CONTROL ROOM DESIGN REVIEW

Human Engineering Discrepancies

BEAVER VALLEY POWER STATION UNIT 2

HUMAN ENGINEERING DISCREPANCIES

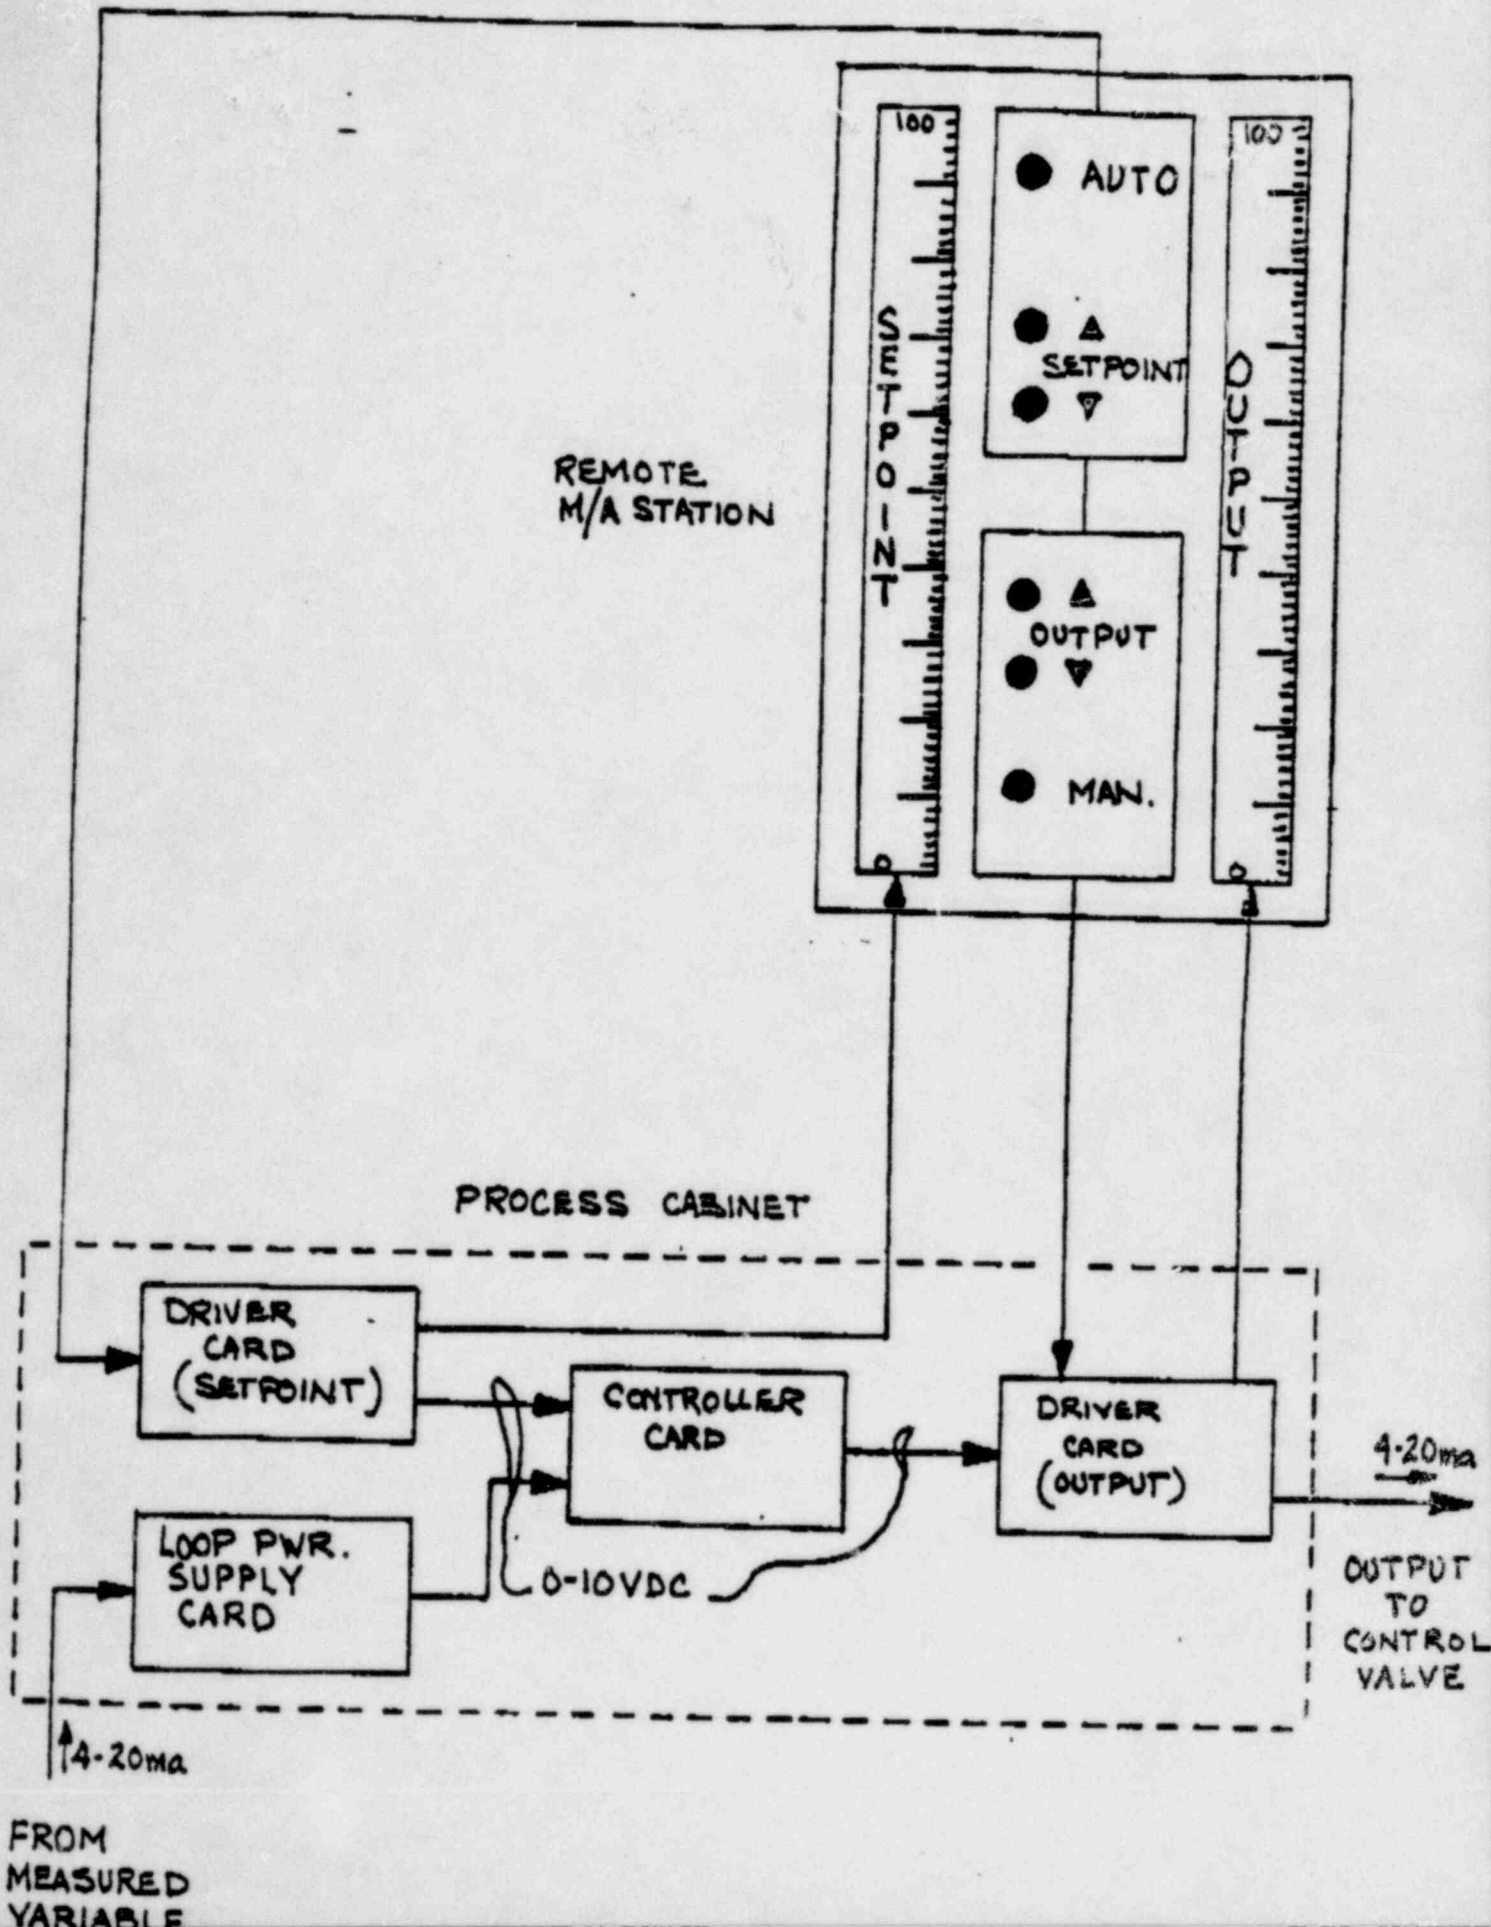
2MSS*PT101A,B,C provide individual 4-20ma signals to the process cabinets. There, the 4-20ma signal is converted to a corresponding 0-10VDC signal, by the loop power supply card, for use internally within the process cabinets. Additionally, the setpoint driver card continuously generates a 0-10VDC setpoint signal and adjusts it's output when it receives a digital increase/decrease signal from the remote M/A station. The controller card receives both the process signal and the setpoint signal, compares them, and generates a control signal output to the output driver card. The output driver card, in turn, converts the 0-10VDC control signal to a 4-20ma control signal which is the output from the process cabinets to the control valve. In this case 2SVS*PCV101A,B,C

The important point in all this, is that since the controller card compares the setpoint to the process signal, and not to valve position, the setpoint is defined as the control point expressed as a percentage of the overall process range (ie. When you adjust the setpoint you are not adjusting valve position, you are adjusting at what percentage of the transmitter ^{Calibrated} range you want the pressure to be controlled at.)

* note: although the setpoint, as indicated on the M/A station, is not expressed in process units (ie. PSIG) it can easily be determined as shown below:

THE CONTROLLERS FOR THE ATMOSPHERIC STEAM DUMP VALVES DO ALLOW AN OPERATOR TO SET AND MAINTAIN A PRESSURE WHEN THE CONTROLLER IS PLACED IN AUTOMATIC. SEE ATTACHMENT 2 FOR EXPLANATION OF CONTROLLER OPERATION. TO OBTAIN A DIRECT READING OF THE PRESSURE SETPOINT SELECTED, ~~IN~~ A SUPPLEMENTAL SCALE GRADUATED IN PSIG COULD BE PLACED NEXT TO THE SETPOINT SCALE (GRADUATED IN 0 TO 100%) OF THE CONTROLLER, IF DESIRED.
